Proposed Repowering of an Existing 46.5m to blade tip Wind Turbine by installing a Replacement 77m to blade tip Wind Turbine, at land to the west of the Energy Coast Business Park, Haile

RESPONSE TO THE CUMBERLAND COUNCIL COMMENTS ON LANDSCAPE AND VISUAL IMPACT ASSESSMENT, JULY 2024

This Response addresses the issues raised and suggested recommendations set out in the Landscape and Visual Assessment Review by Galpin Landscape Architecture (dated July 2024), for the proposed replacement of an existing turbine located west of The Energy Coast Business Park, off the A595.

WFPN-0001b
Viewpoint 08: Cold Fell

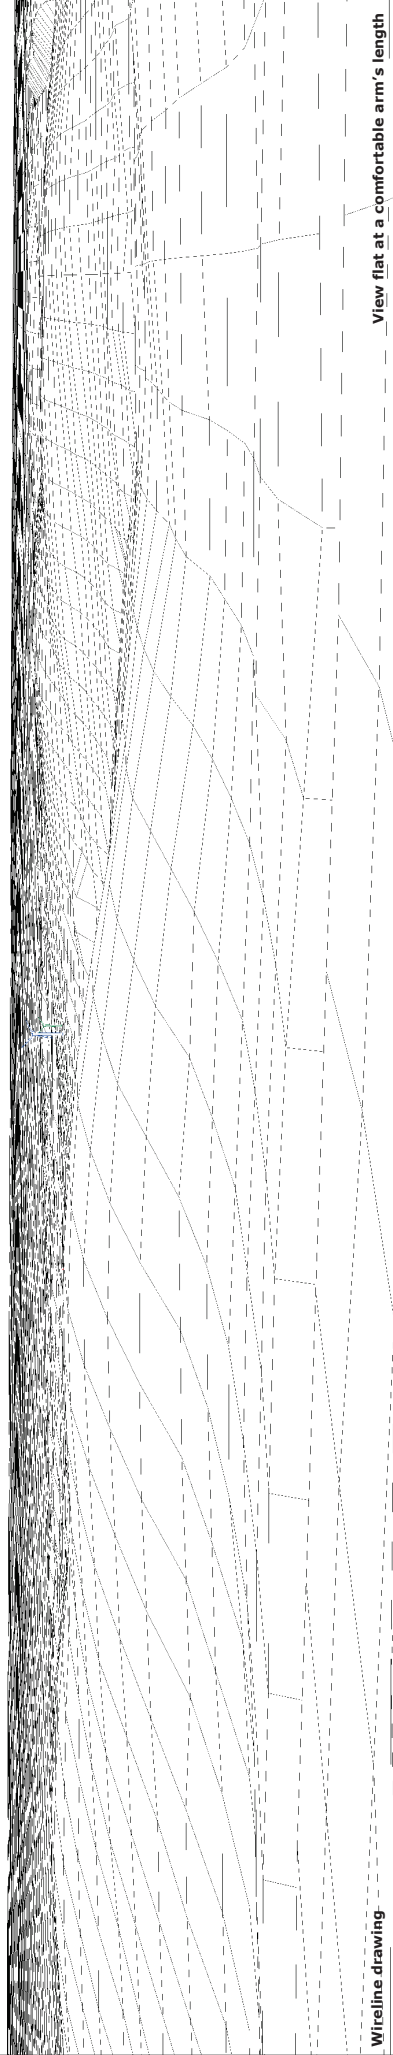
Closest views of the Proposed Development would be from the western edge of the LDNP, as a distance of approximately 2.5km. To inform this Response, and as requested in the Galpin Review, a wireline with Google Streetview photography for reference, has been provided (Viewpoint 8: Cold Fell, Application LVIA). This illustrates the location of the Proposed Development relative to the edge of the LDNP demonstrating the panoramic and large-scale nature of the visibility available.

Viewpoint 8: from the edge of the LDNP

This viewpoint is illustrated with a Google Streetview photograph and a wireline. This is sufficient to appreciate the large scale of the views available from the limited areas of potential visibility on the elevated slopes of the LDNP. The change in scale and height from the existing to the replacement turbine would be barely discernible in views from the edge of the LDNP, and only available in good visibility. It is noted that Sellafield is a clearly defined feature within this view.

The visualisation supports the assessment in the Landscape Assessment section above that the effect on the LDNP will be Minor-None.
